PERRY NUCLEAR POWER PLANT
10 CENTER RD., PERRY, OHIO 44081

Information Only
New Figure

Information Only
CN=Change

Figure 2.5-48

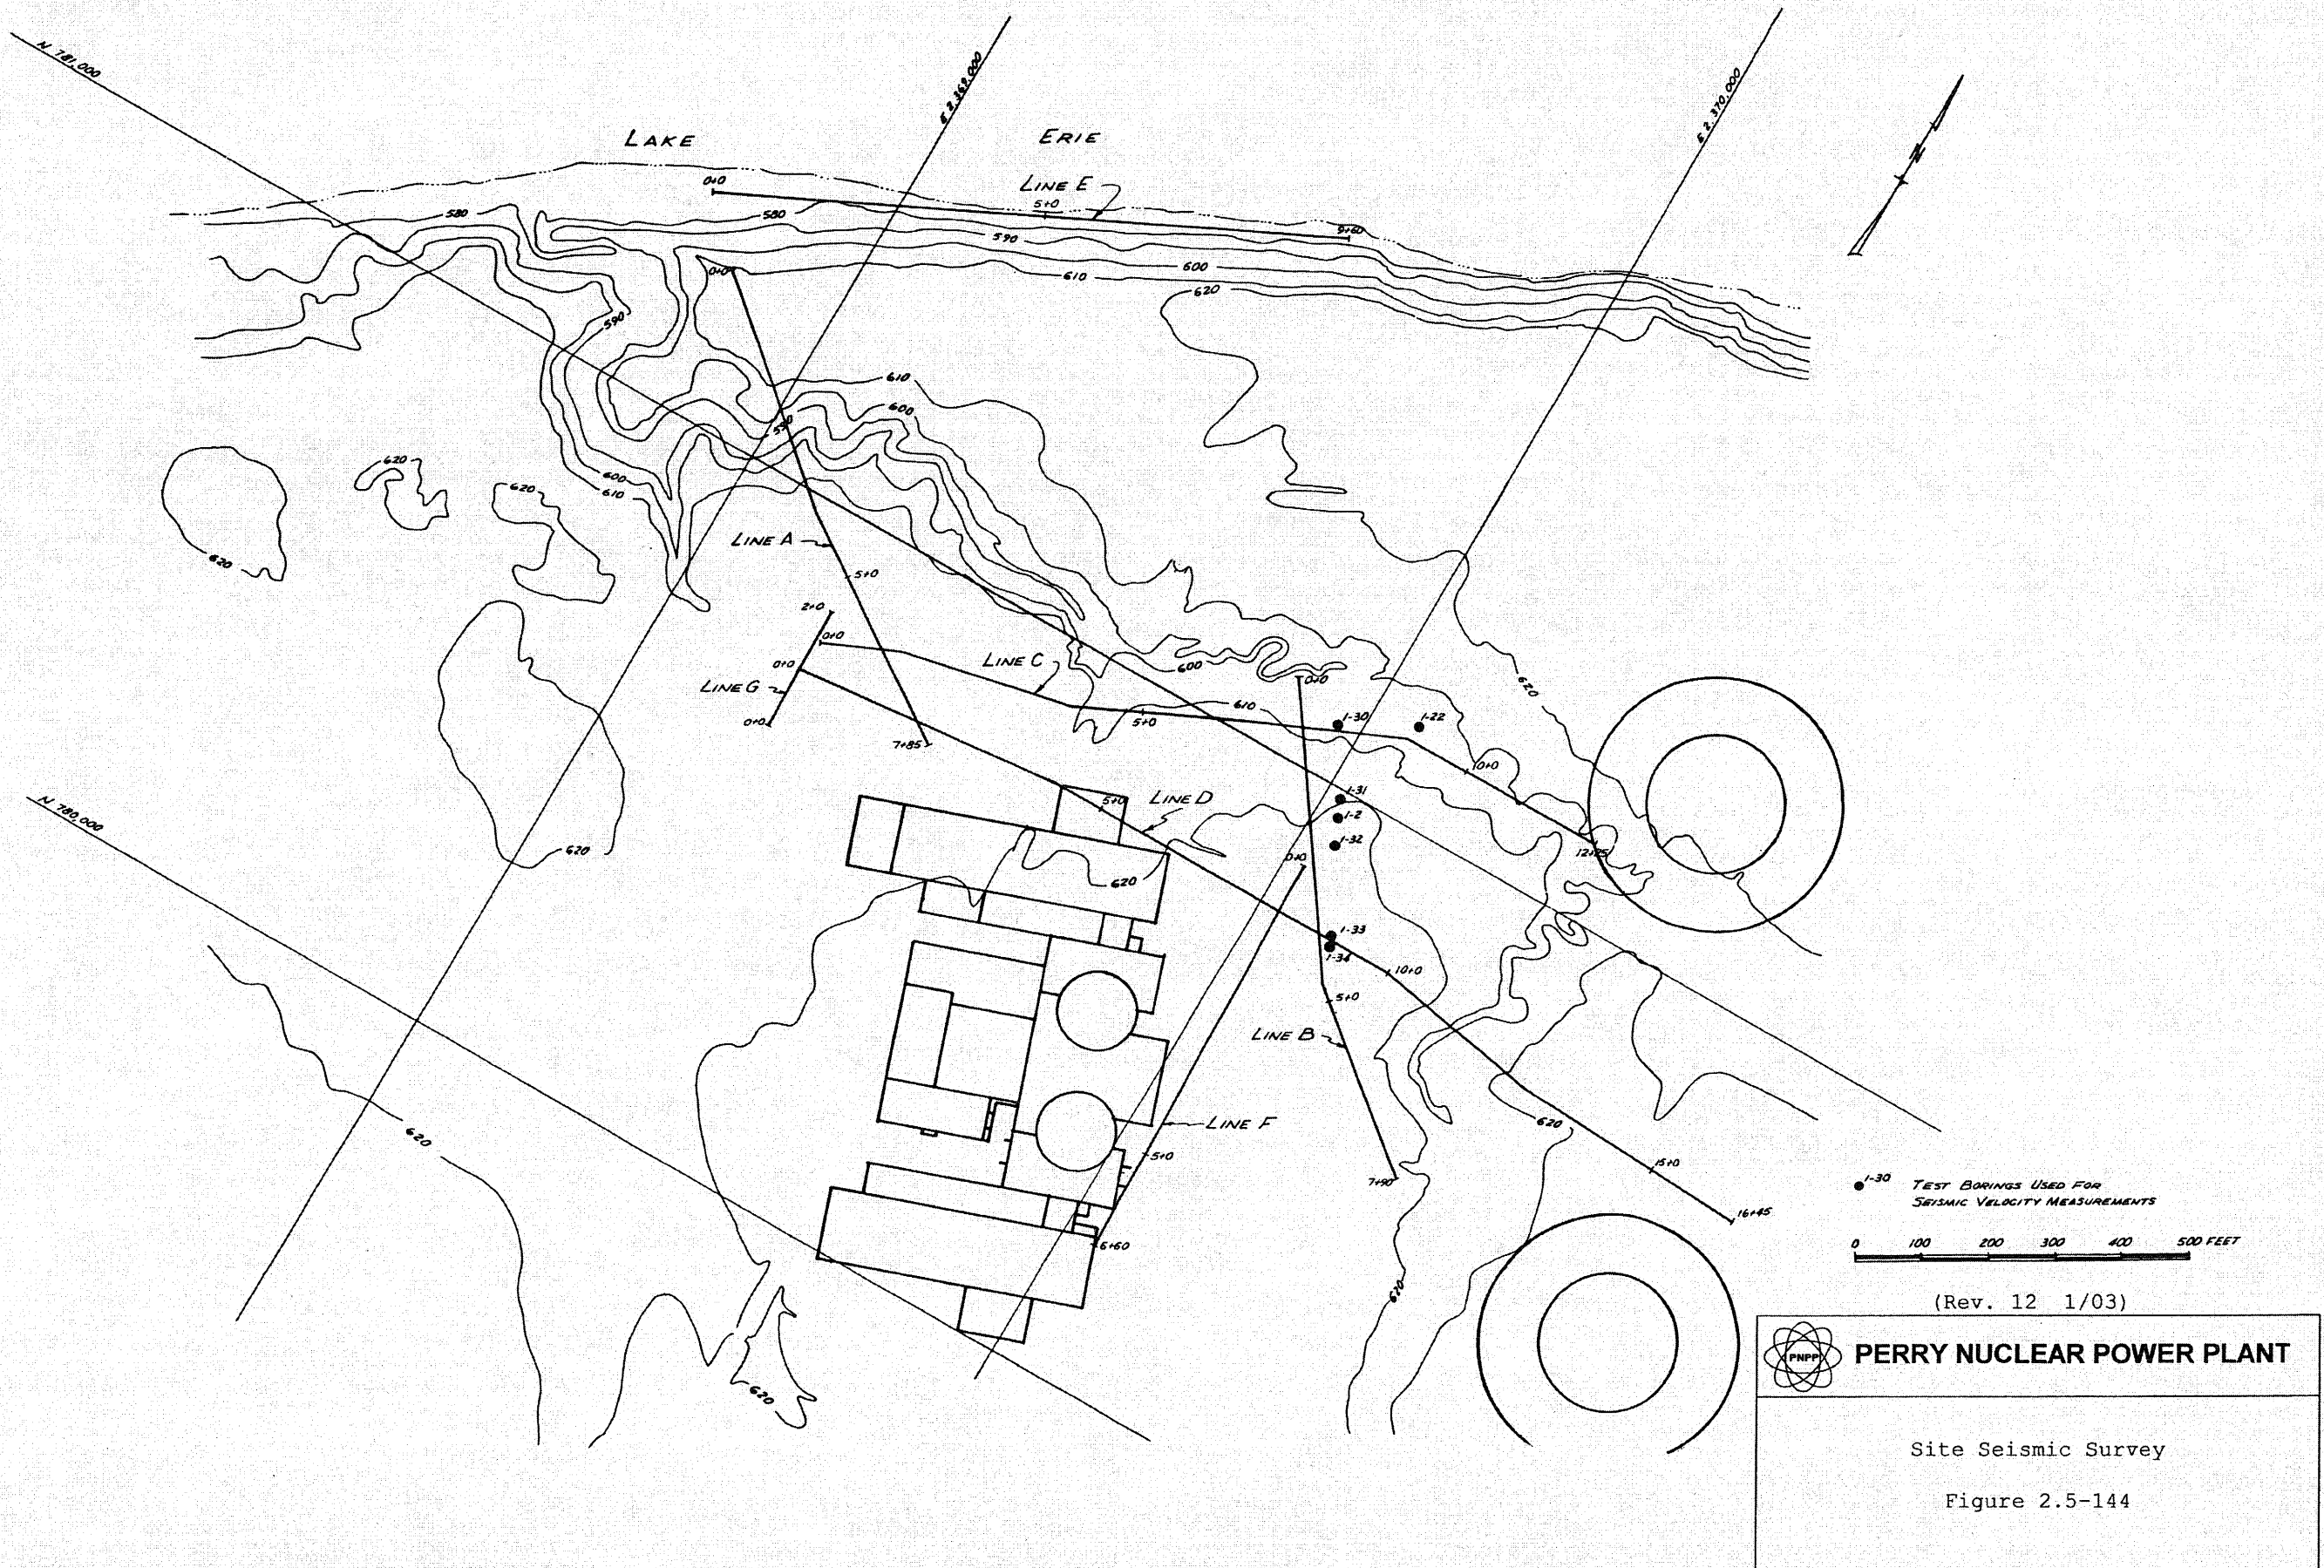
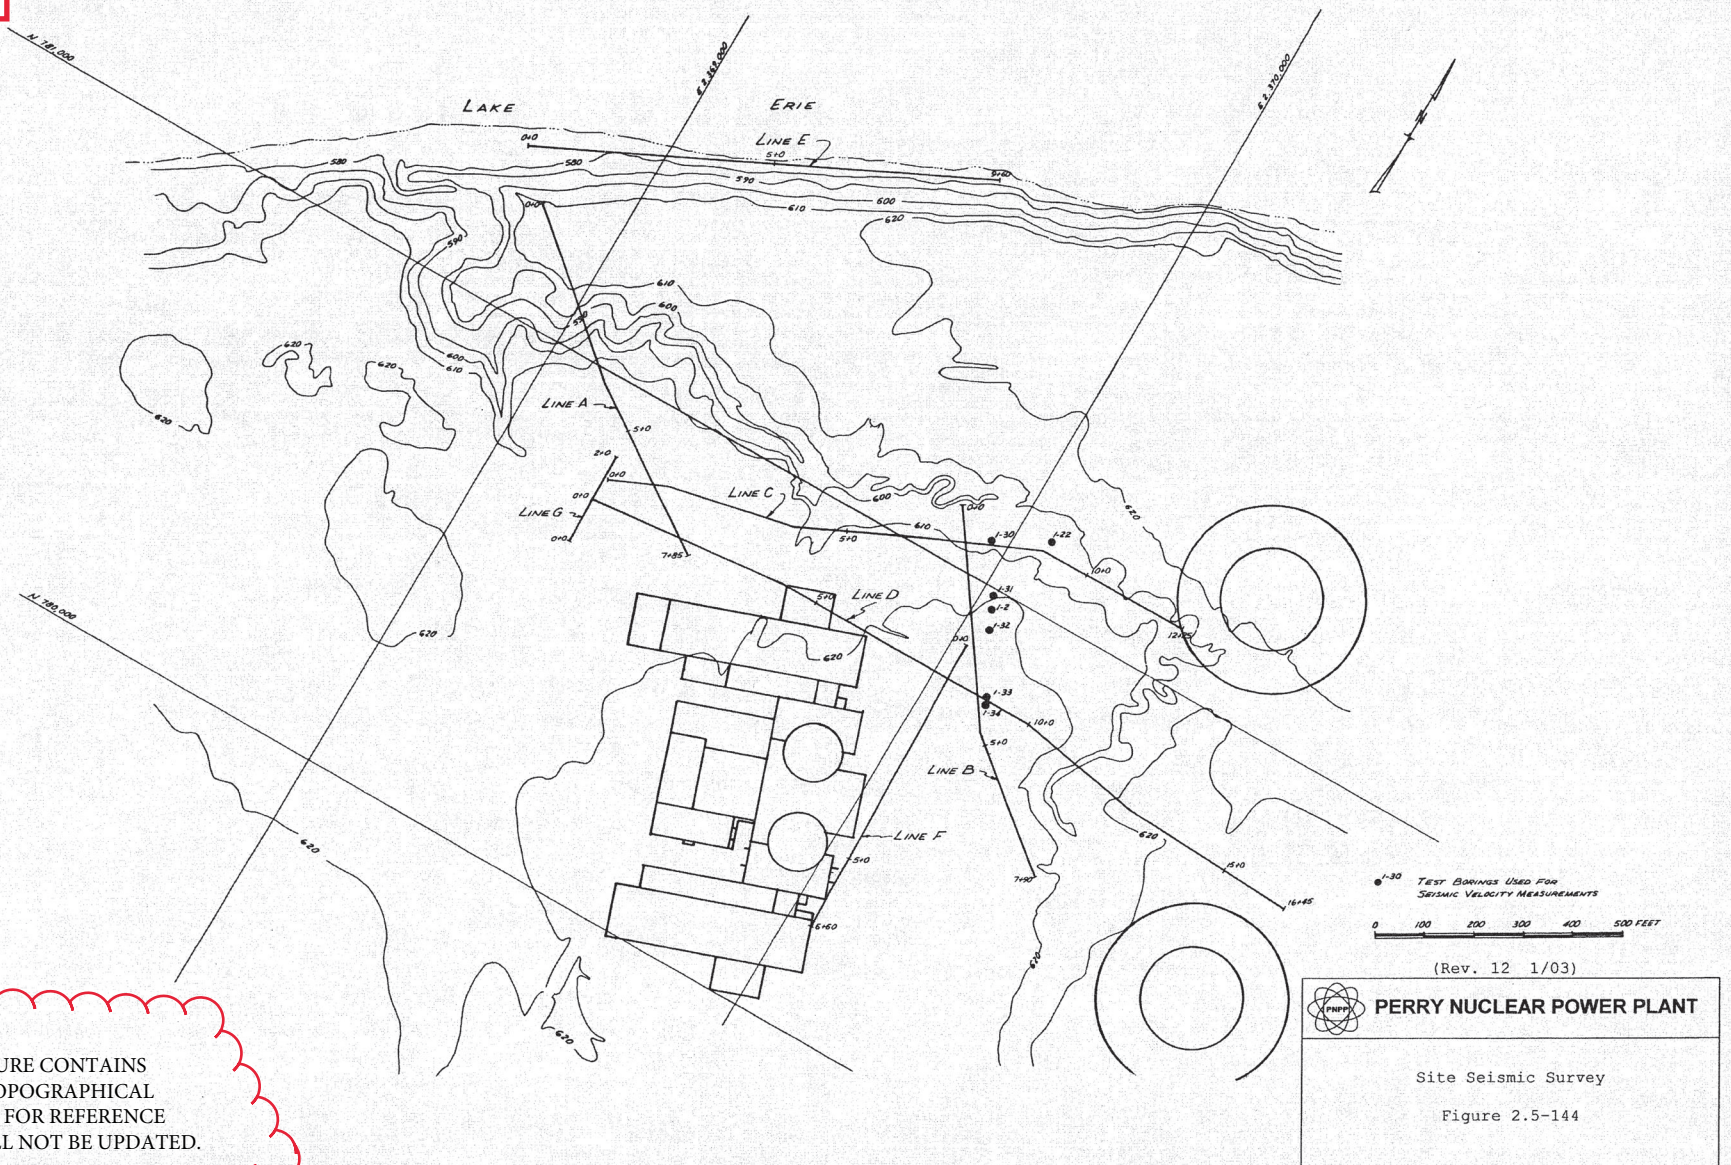
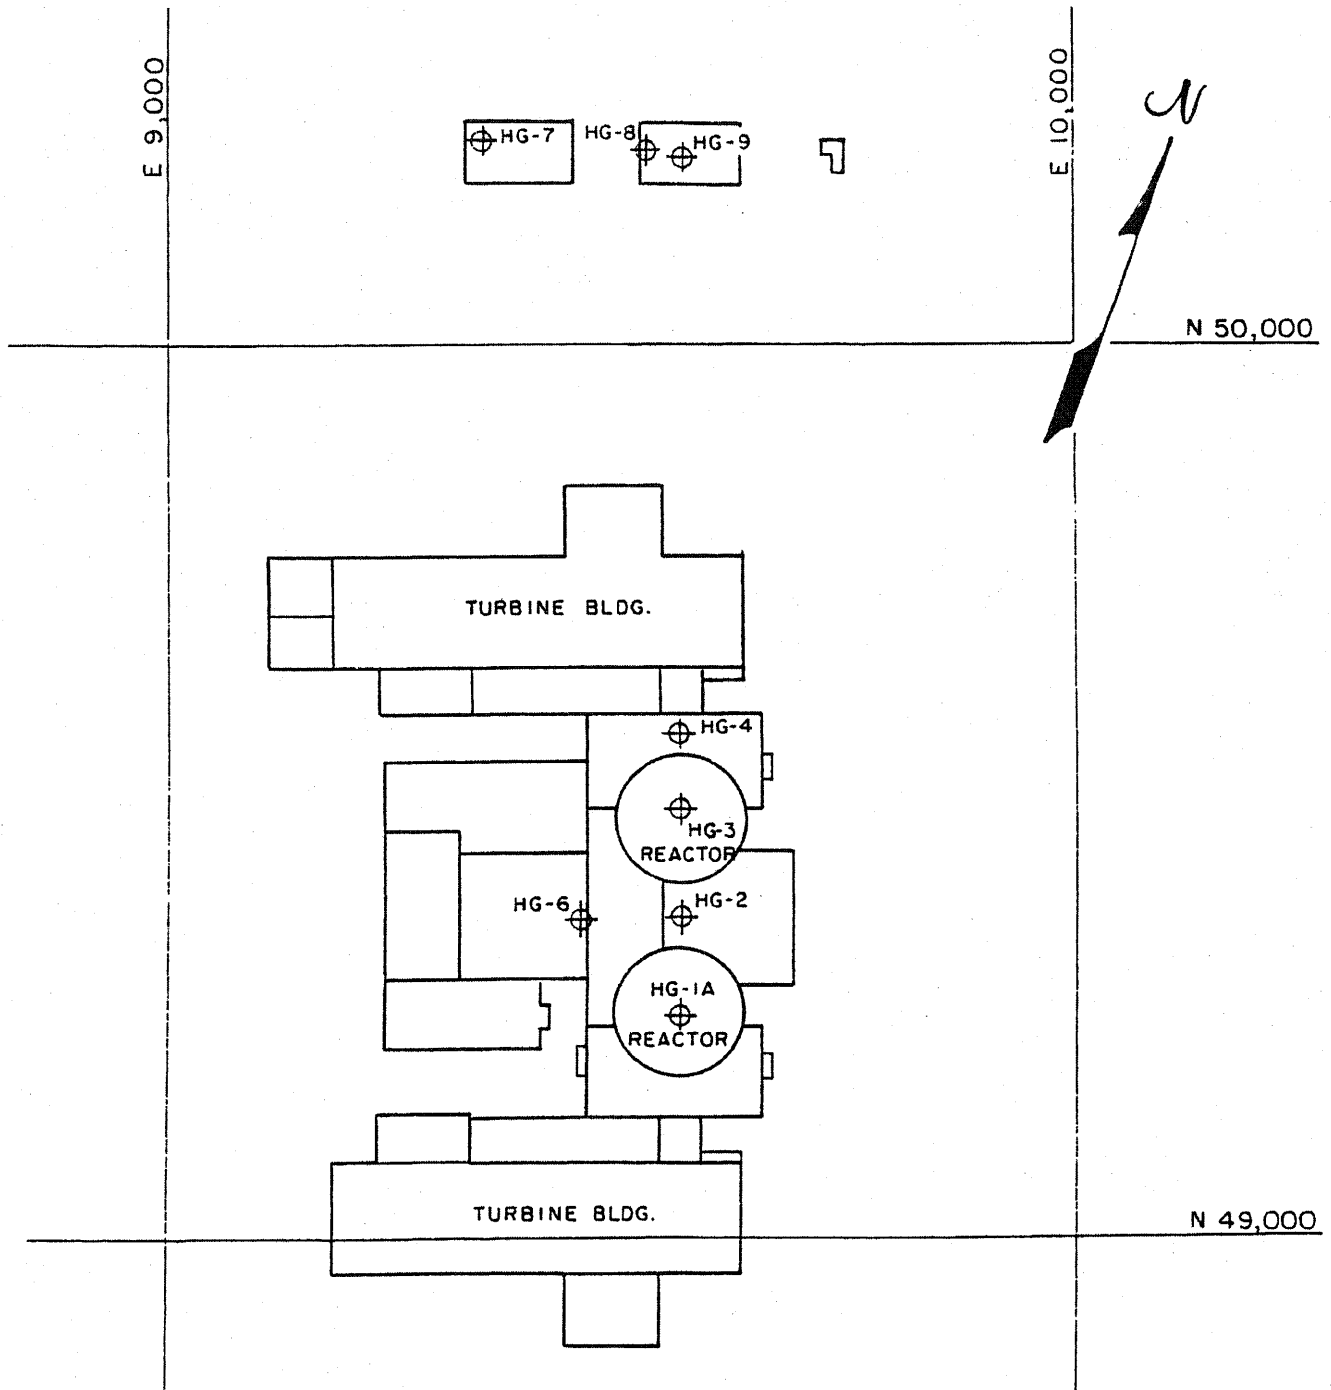
ADD NOTE
THIS CN

NOTE:
THIS USAR FIGURE CONTAINS
HISTORICAL TOPOGRAPHICAL
INFORMATION FOR REFERENCE
ONLY AND WILL NOT BE UPDATED.
